COMMONWEALTH OF KENTUCKY
BEFORE THE KENTUCKY STATE BOARD ON ELECTRIC
GENERATION AND TRANSMISSION SITING

<i>Electronic</i> Application of Golden Solar, LLC)	
for Certificate of Construction for an)	
Approximately 100 Megawatt Merchant)	Case No.
Electric Solar Generating Facility in Golden)	2020-00243
County, Kentucky)

Response to Siting Board Staff's Second Request for Information

DATE: 11/18/2022 REV:
 SHEET: EE101 A

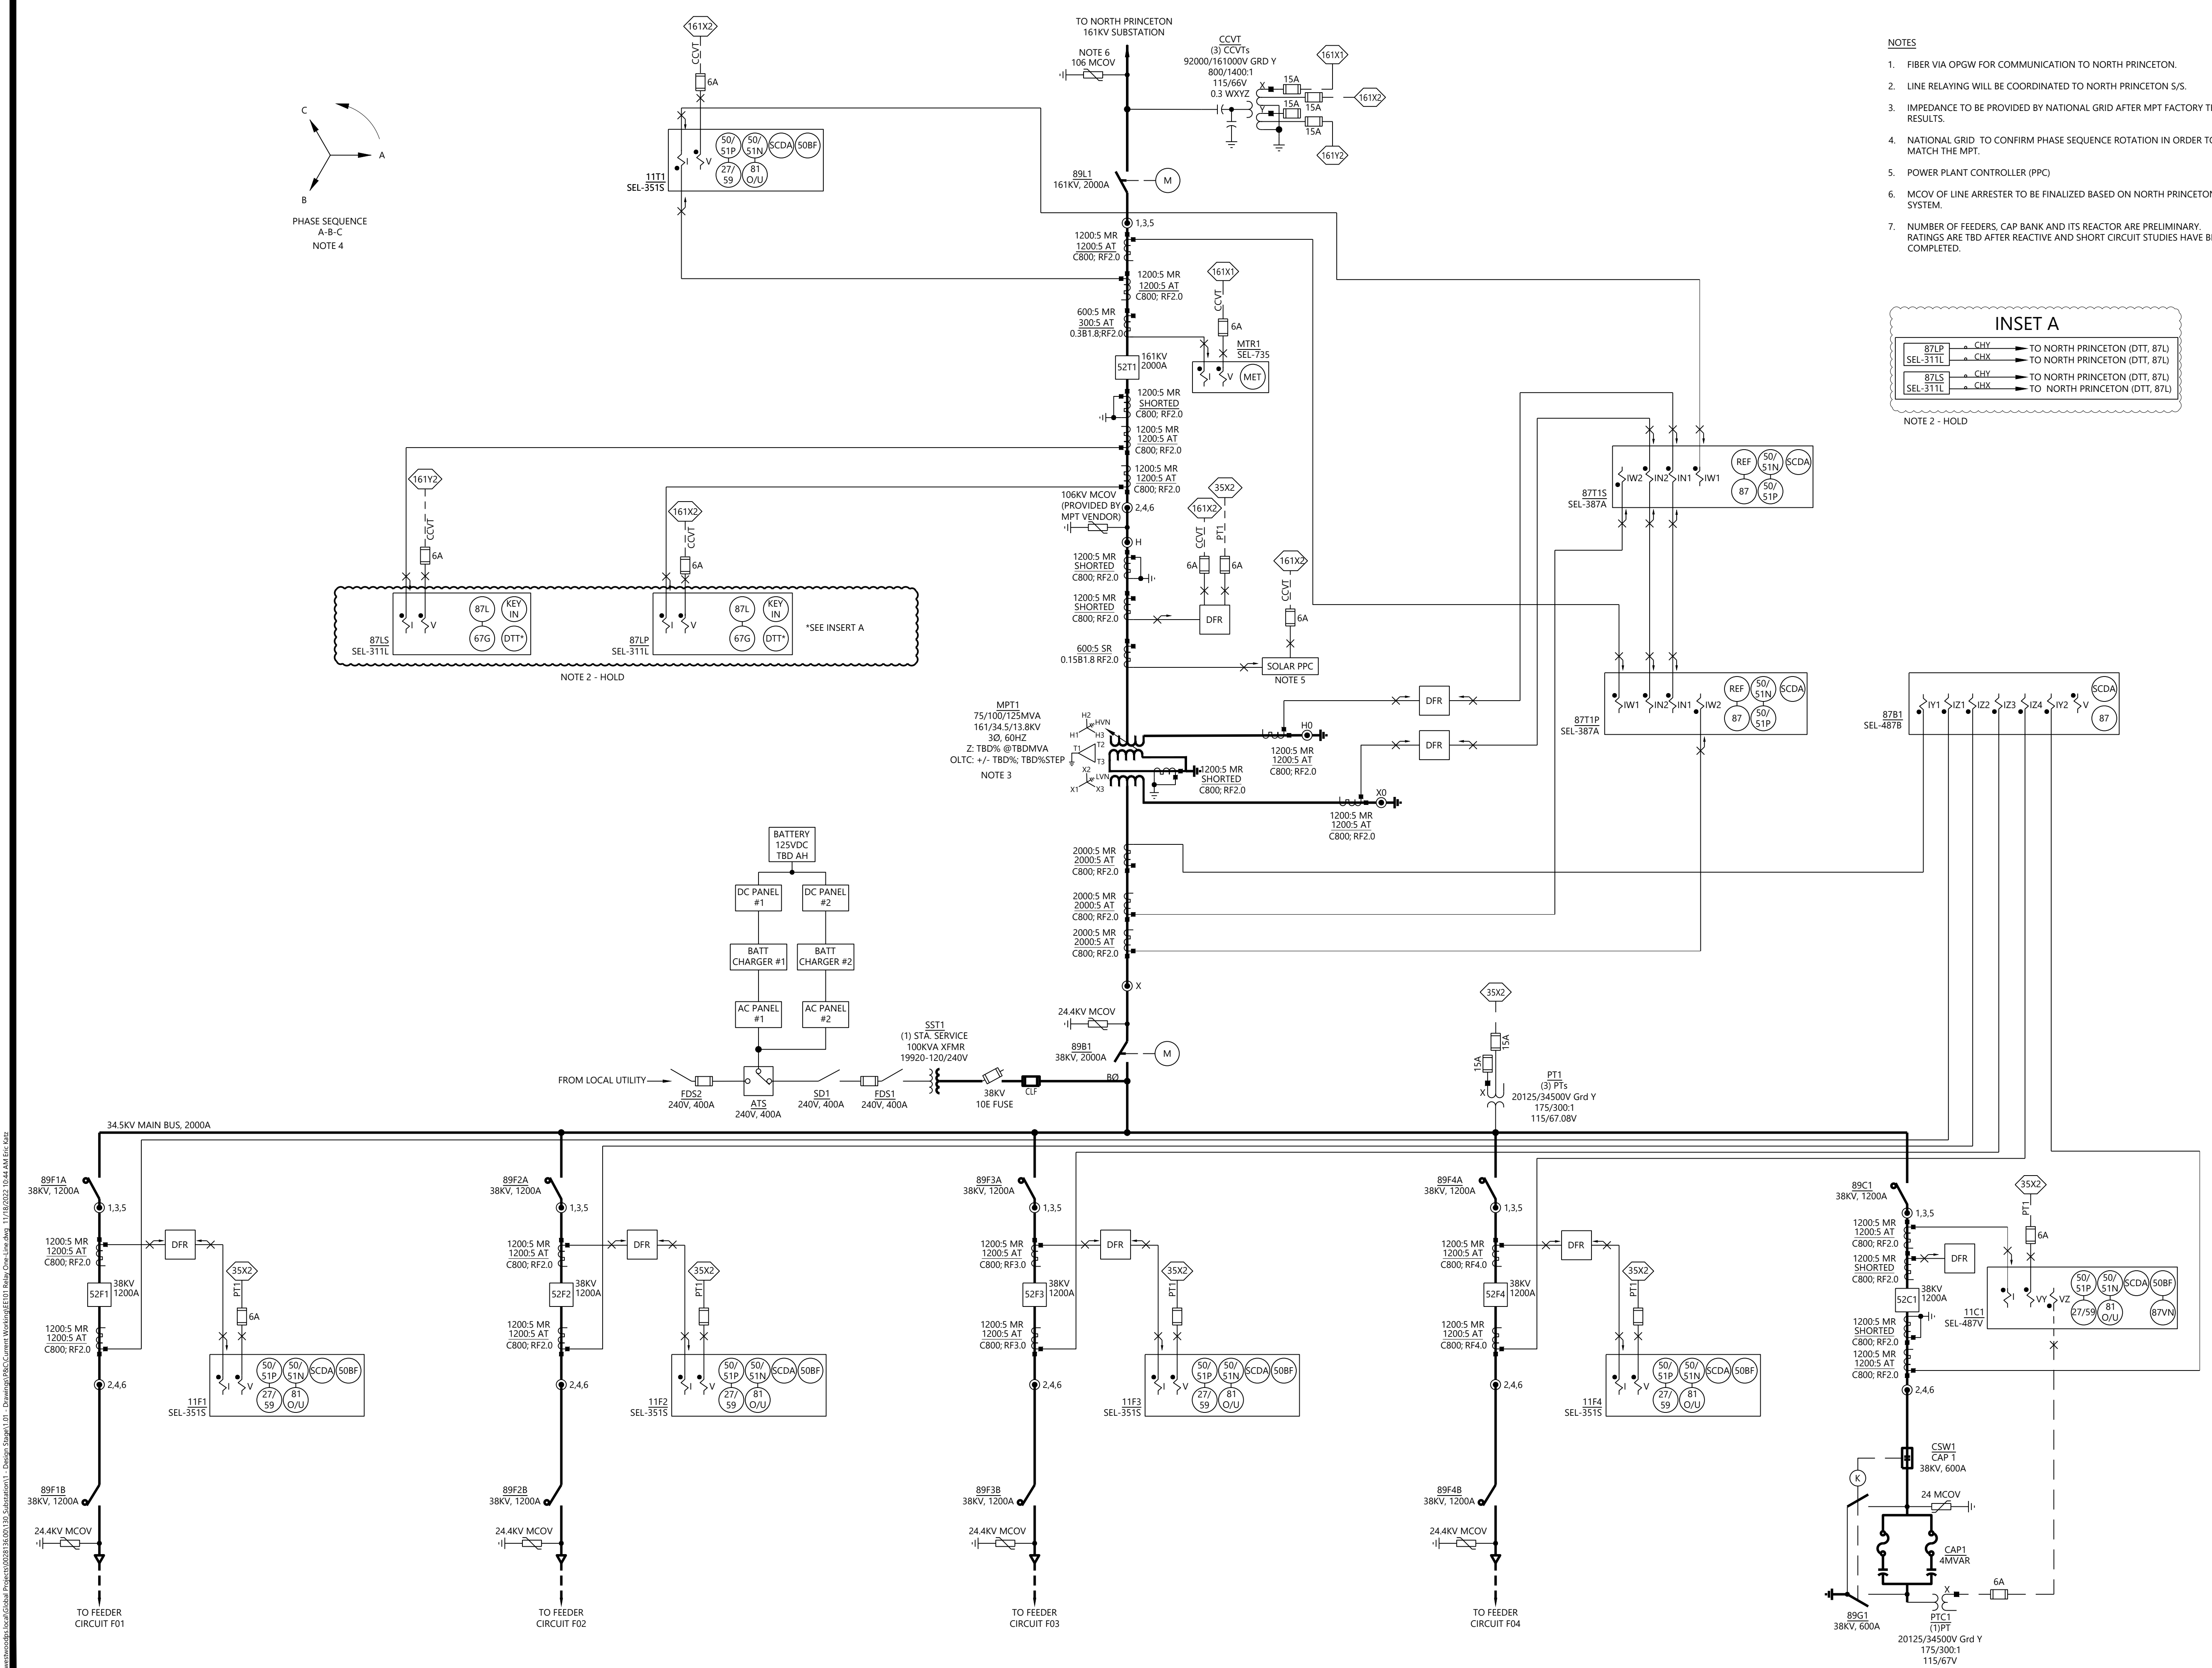
16. Refer to the Response to Staff's First Request, Item 29. Provide the One- line diagram that includes the Main Substation of the Project and the existing utility substation.

See attached diagram. The point of interconnection at the existing utility substation is shown at the top of Sheet EE101. Golden Solar does not have a one-line diagram of the existing utility substation at this time.
